VIRGINIA ELECTRIC AND POWER COMPANY
RICHMOND, VIRGINIA 23261

VIRGINIA ELECTRIC AND POWER COMPANY
NORTH ANNA POWER STATION UNITS 1 AND 2
PROPOSED LICENSE AMENDMENT REQUEST
OPEN PHASE PROTECTION PER NRC BULLETIN 2012-01
RESPONSE TO REQUEST FOR ADDITIONAL INFORMATION

Response to NRC Request for Additional Information
Regarding the
Proposed License Amendment Request
Open Phase Protection per NRC Bulletin 2012-01

RESPONSE TO NRC REQUEST FOR ADDITIONAL INFORMATION
NORTH ANNA POWER STATION UNITS 1 AND 2

**One-line Diagrams Highlighting the Power Feed from the Transformers/Switchyard
to the Safety Related Buses**

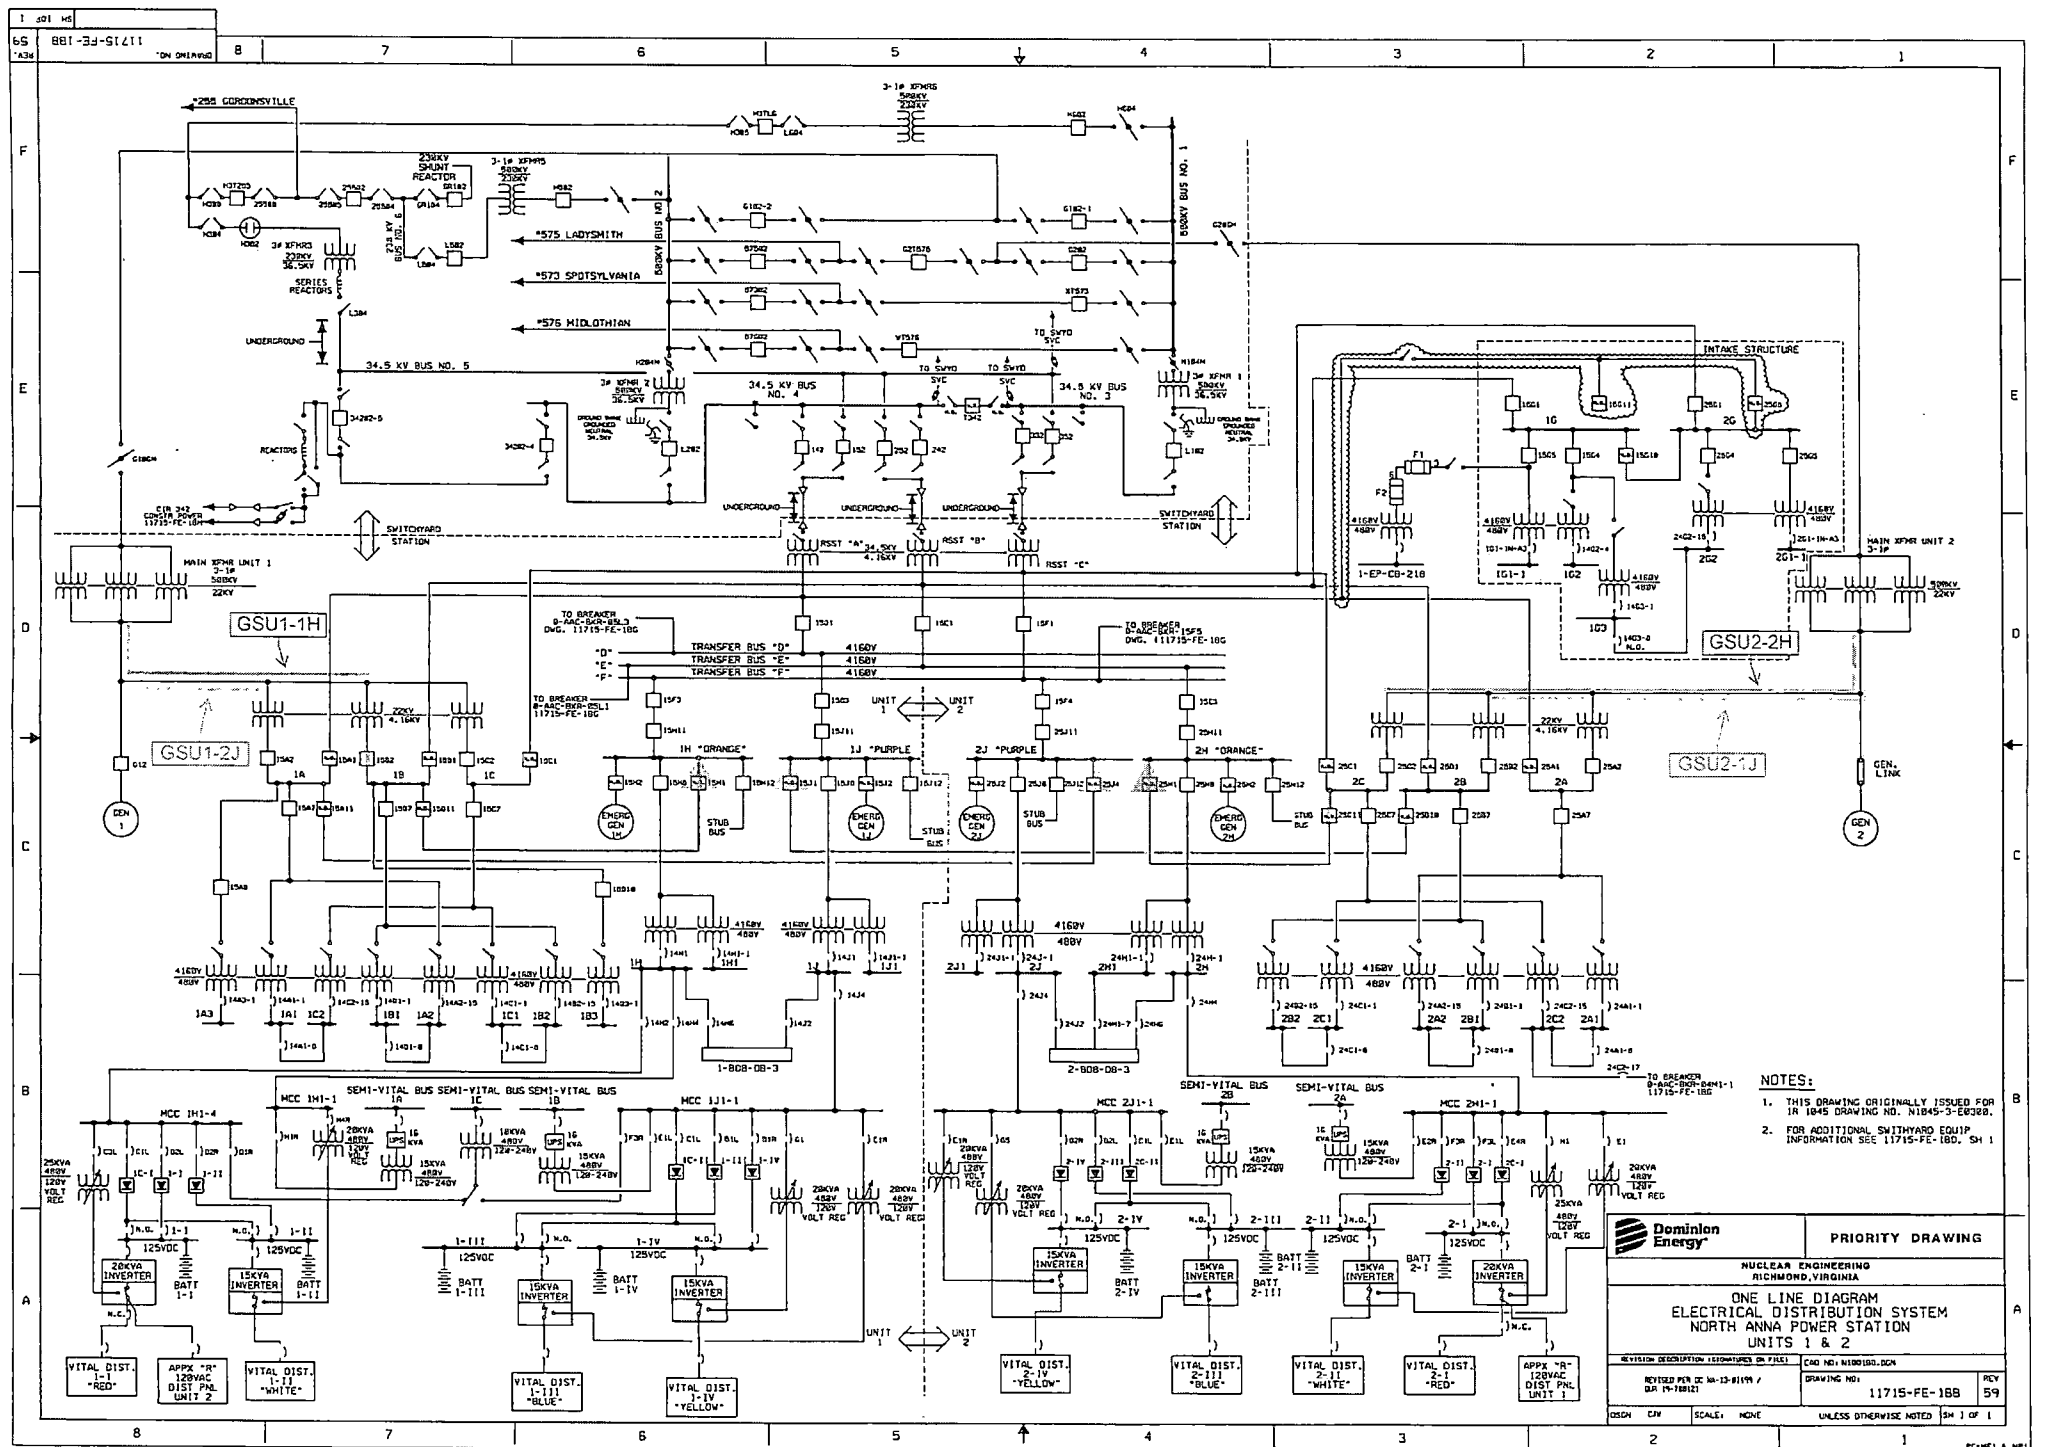
Please explain why two open phase locations have been considered for each GSU (e.g., GSU 1-1H, GSU 1-2J), whereas according to the LAR, Attachment 1, Page 11, only one open phase location has been considered on high side of each GSU. For the various operating conditions, please provide one-line diagrams highlighting the power feed from the above transformers/switchyard to the safety related buses.

One location is considered for each GSU (OPC on the high side of the GSUs). Two plant configurations are considered based on possible Station Service Bus to Emergency Bus cross-tie configurations. The one-line diagrams highlighting the power feed from the above transformers/switchyard to the safety related buses is provided in Attachment 6.

Logic Diagram for Negative Sequence Voltage Relay Scheme

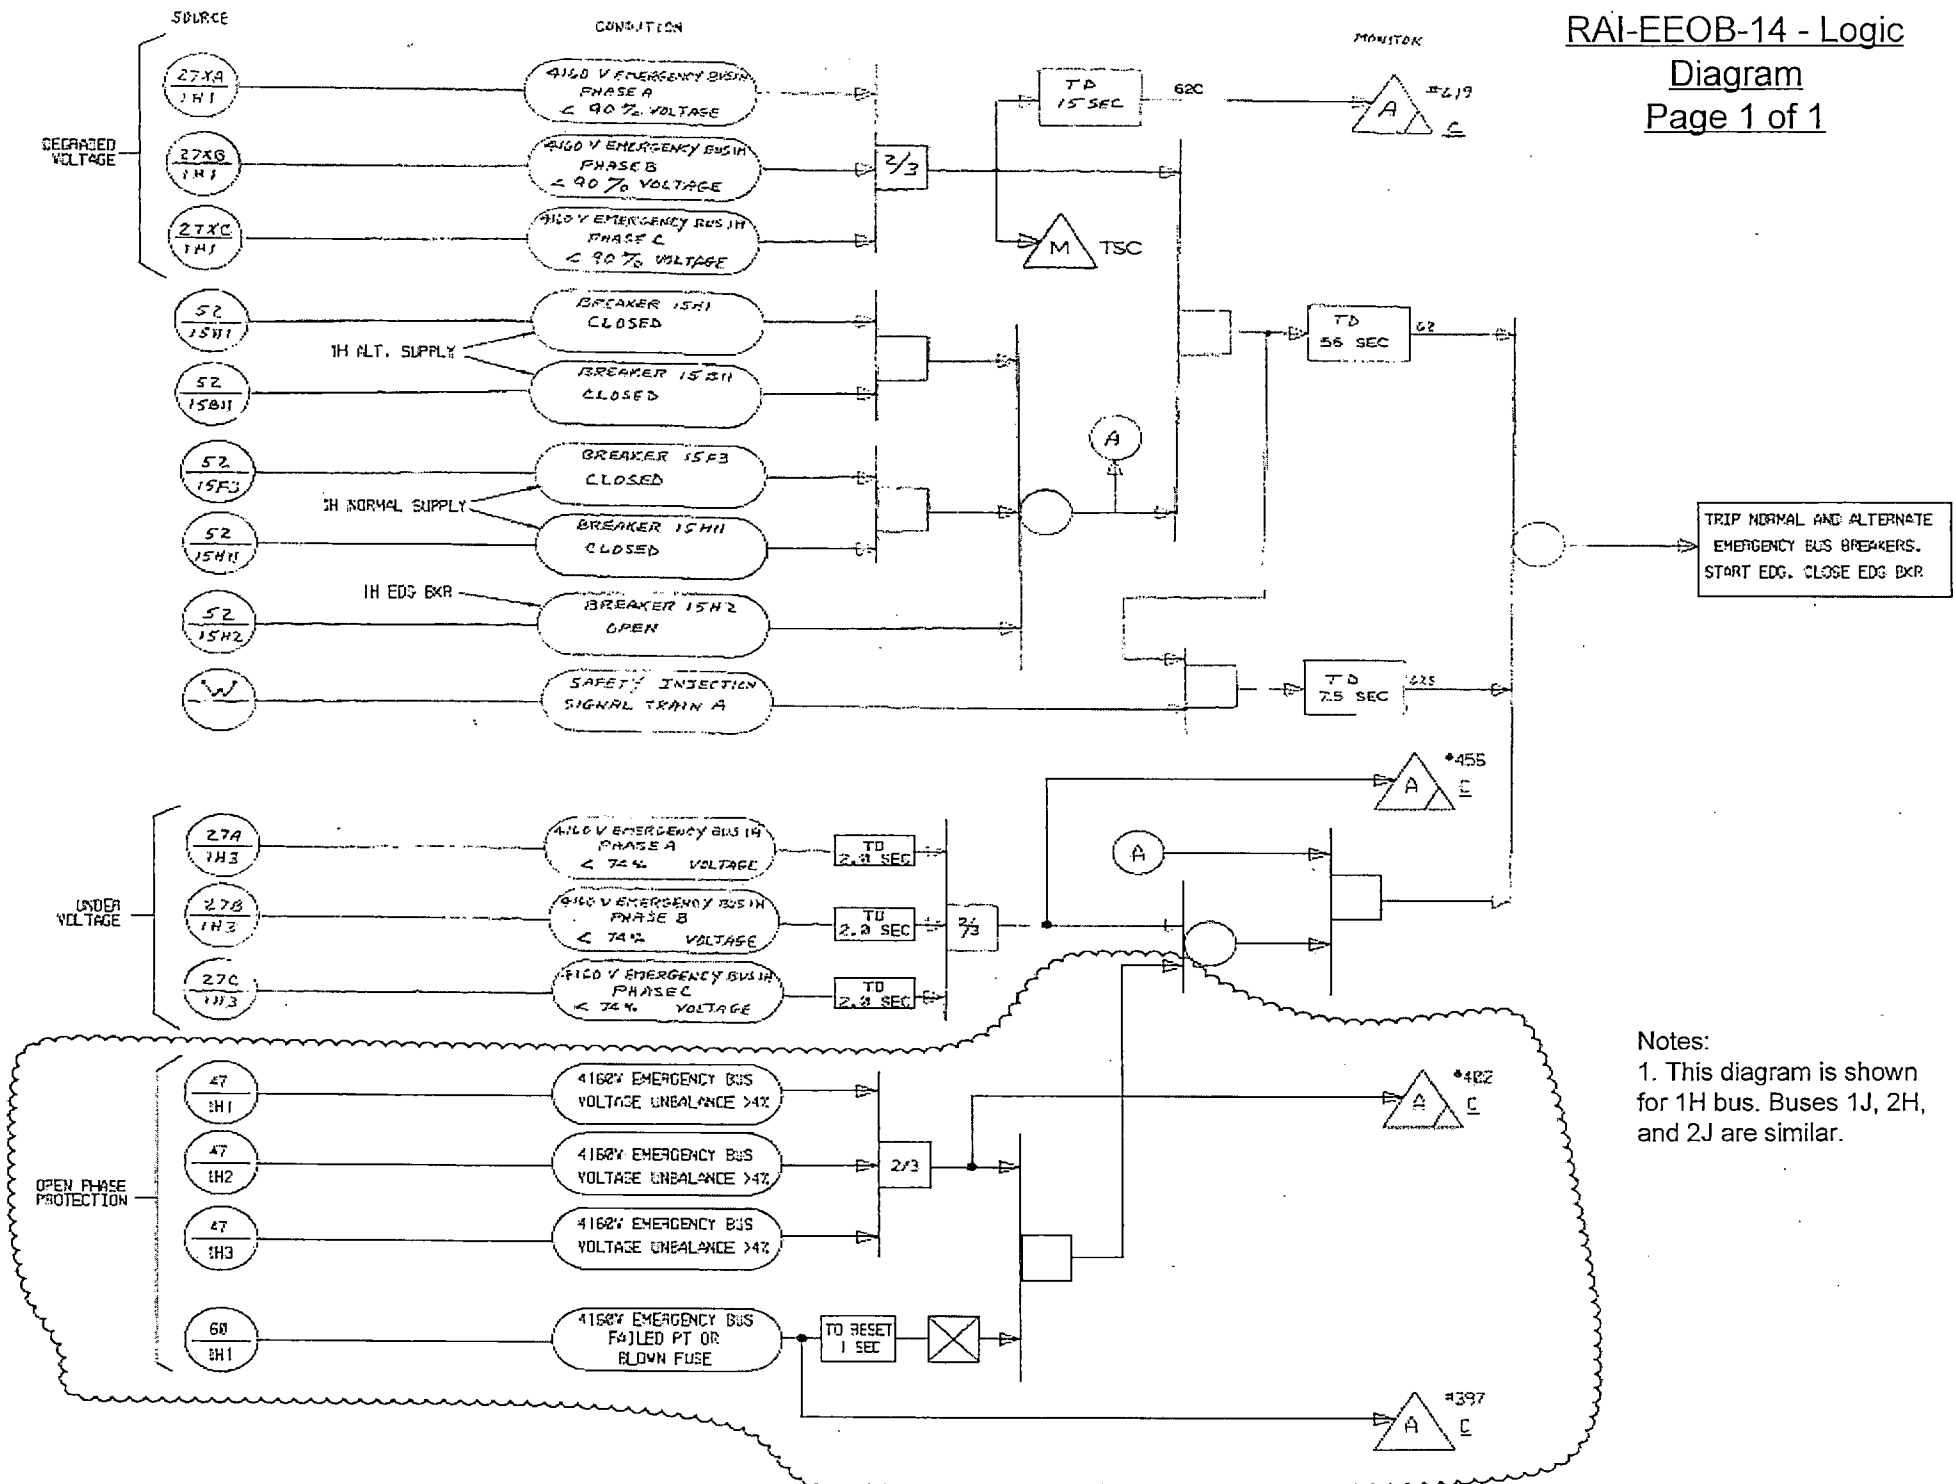
Please provide a logic diagram and provide a discussion that clearly demonstrate the negative sequence voltage relay scheme (detection, alarm, and protection), including the feature that blocks actuation of the negative sequence voltage (open phase) protection using the ABB 60 (voltage balance) relay. Also discuss how that scheme interfaces with the existing undervoltage (UV) and degraded voltage (DV) relay protection schemes, which trip the offsite power circuits at the ESF bus level and initiate the EDG starts.

A logic diagram is provided in Attachment 8 to illustrate the negative sequence voltage relay scheme and how it interfaces with the existing undervoltage relay protection scheme. The logic diagram provided is for Emergency Bus 1H; Emergency Buses 1J, 2H, and 2J are similar. A description of the scheme is provided below.

The open phase protection system is being implemented on each of the four Emergency Buses. The system consists of three Basler BE1-47N negative sequence relays, with each relay detecting all three phases, connected to each of the emergency bus (1H, 1J, 2H, and 2J) potential transformers (PTs). The three negative sequence relays each contain an auxiliary relay, which is used to develop a two-out-of-three logic scheme. This requires two or more relays to sense a voltage imbalance greater than 4% (i.e., an OPC) to initiate protection of the emergency bus.

The open phase detection scheme is inserted into the existing undervoltage protection circuit for each Emergency Bus. The initiation of an undervoltage or open phase actuation, requires that the emergency bus is being fed from an off-site power source. The parallel input (undervoltage and open phase) feeds an additional parallel circuit containing 52 contacts of each source of offsite power. To include this logic in the protection scheme, wiring is installed to 52 contacts at the respective breakers that supply offsite power to the emergency bus.

Additionally, a feature that blocks the open phase system protection actuation is also included in the logic scheme. This feature enhances the reliability of the protection system and prevents the protection scheme from actuating in the event of a failed or degraded 4kV bus PT or blown PT fuse. To achieve this feature, one ABB 60 voltage balance relay is installed per bus. The relay compares 4kV Emergency Bus PT voltages with 480V Emergency Bus PT voltages. Relay contact outputs specific to each voltage source actuate if the given source lowers to the voltage difference setpoint. The 480V PT source output contact is not used; however, the relay may activate that contact for a 480V bus transient, fault, or other event on the 480V system that causes that voltage input to the relay to reach the setpoint. If a 4kV PT failure occurs, the relay senses a voltage imbalance and opens an auxiliary relay contact which blocks the open phase protection system. One relay contact is also used to operate a white light on the front of the relay panel that will alert operators that open phase protection is disabled.
